# Access Compliance Report

## Public Rights-of-Way

### (Curb Ramps)

Intersection ID: 7979	Main Street: EAGLE_PEAK_DR	Cross Street: DAVID_AV	Location:	N/A
ADA ID: CA9878095A3F	Ramp Type: Perp	Initial Pass/Fail: Fail	Overall Compliance: No	Severity Score: 10

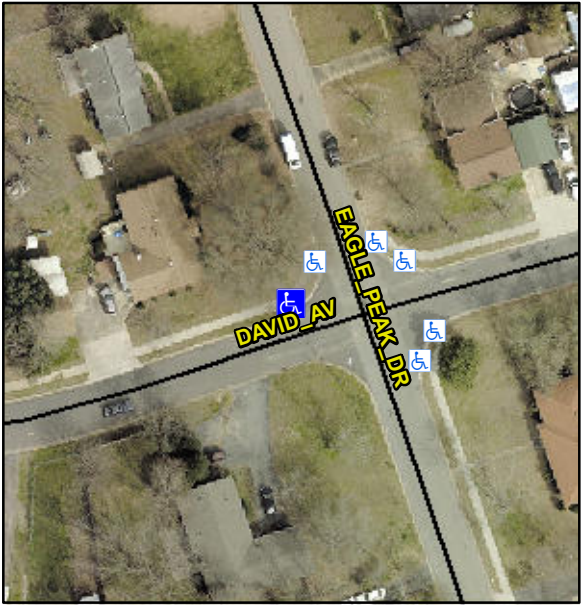
Codes/Mitigation Info/Possible Solution			Field Measurements/Component Compliance		
	Possible Solutions:		<b>Compliance</b>	<b>Description</b>	<b>Data</b>
	<b>Remove &amp; Replace Entire Ramp.</b>		<b>N/A</b>	Ramp Length (in)	<b>49.0</b>
			<b>No</b>	Ramp Width (in)	<b>47.0</b>
			<b>N/A</b>	Flare Type LT	<b>N/A</b>
			<b>N/A</b>	Flare Slope LT (%)	<b>N/A</b>
			<b>N/A</b>	Flare Traversable LT?	<b>N/A</b>
			<b>N/A</b>	Landing Length (in)	<b>N/A</b>
			<b>N/A</b>	Landing Width (in)	<b>N/A</b>
			<b>N/A</b>	Landing Slope (%)	<b>N/A</b>
			<b>N/A</b>	Landing X Slope (%)	<b>N/A</b>
<p>Surveyor Notes:</p> <p><b>N/A</b></p> <p>PROW/ADA:</p> <p><b>Not Found, R304.5.1</b></p>			<b>N/A</b>	Flare Type RT	<b>N/A</b>
			<b>N/A</b>	Flare Slope RT (%)	<b>N/A</b>
			<b>N/A</b>	Flare Traversable RT?	<b>N/A</b>
			<b>N/A</b>	DWS Provided?	<b>N/A</b>
			<b>N/A</b>	DWS Contrast?	<b>N/A</b>
			<b>N/A</b>	DWS Length (in)	<b>N/A</b>

<b>N/A</b>	DWS Full Width?	<b>N/A</b>
			<b>N/A</b>	DWS Offset (in)	<b>N/A</b>
			<b>N/A</b>	Gutter Ponding?	<b>N/A</b>
			<b>N/A</b>	Gutter Lip Ht (in)	<b>0.5</b>
			<b>N/A</b>	Painted X Walk1?	<b>No</b>
				X Walk 1 Direction	<b>To S</b>
			<b>N/A</b>	X Walk 1 Width (in)	<b>N/A</b>
				X Walk 1 Slope (%)	<b>3.4</b>
				X Walk 1 X Slope (%)	<b>3.0</b>
			<b>N/A</b>	Ramp inside XWalk1?	<b>N/A</b>
				Road Slope (%)	<b>3.0</b>
				Road X Slope (%)	<b>3.4</b>
			<b>N/A</b>	Any Obstructions?	<b>N/A</b>
				Obstruction Type	
Total Cost:					<b>\$ 1850.00</b>
			<b>N/A</b>		<b>N/A</b>
			<b>Yes</b>	Surface Condition? (G/P)	<b>Good</b>
